ASSESSMENT REPORT

DOCKET NO. 72-21

U.S. DEPARTMENT OF ENERGY

TOPICAL SAFETY ANALYSIS REPORT FOR THE CENTRALIZED INTERIM STORAGE FACILITY

Figure 3-1. Centralized Interim Storage Facility (CISF) site plan (based on Figure 4.1-1 of the CISF Topical Safety Analysis Report)

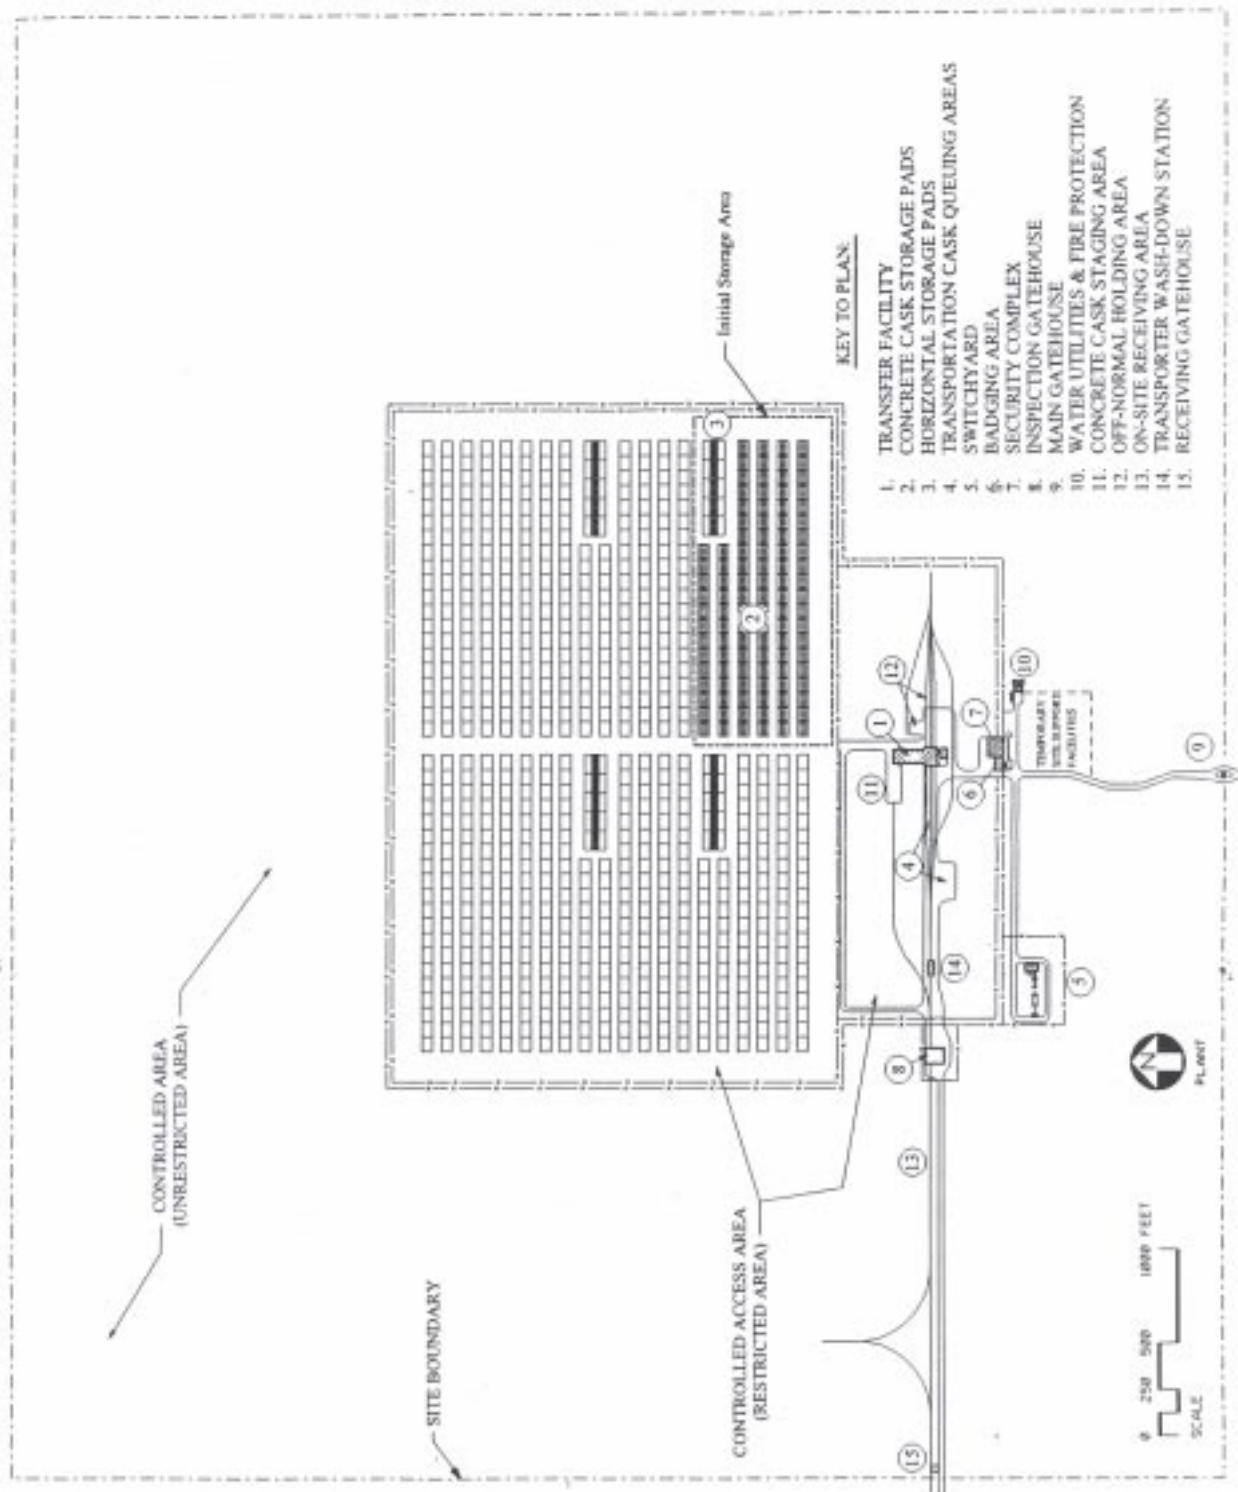
Section 4.1, Installation Design, of the CISF TSAR (U.S. Department of Energy, 1998a) provides a description of the CISF layout and the major buildings, structures, and SNF storage areas (see Figure 3-1). The major functions to be performed at the CISF during the operational period are also identified. The layout of the CISF installation will be based on the generic site characteristics presented in Chapter 2, Site Characteristics, of the CISF TSAR, which are intended to envelop as much of the 48 contiguous United States as is practical. The principal CISF installation features that were summarily described included (i) site boundary, (ii) controlled area, (iii) controlled access area, (iv) switchyard, (v) security complex, (vi) main gatehouse, (vii) water utilities and fire protection, (viii) concrete cask staging area, (ix) receiving gatehouse, (x) on-site receiving area, (xi) inspection gatehouse, (xii) transporter wash-down station, (xiii) transportation cask queuing areas, (xiv) transfer facility, (xv) off-normal holding area, (xvi) storage area and concrete storage pads, (xvii) communications and alarms, (xviii) storage tanks, and (xix) temporary facilities. No stacks will be used at the CISF. The exhaust vent for the transfer facility ventilation system will be located on the side of the transfer facility building.

The storage area has been sized to accommodate 40,000 MTU of SNF. A minimum 200-ft buffer will be provided between the unrestricted area and the closest cask storage. A minimum 2,300-ft distance will be provided from the site boundary to the stored fuel. It is not clear, however, if the off-normal holding area meets this criterion (see Figure 3-1). In addition, the storage capacity and design specifications of the off-normal holding area were not provided. The number of individual
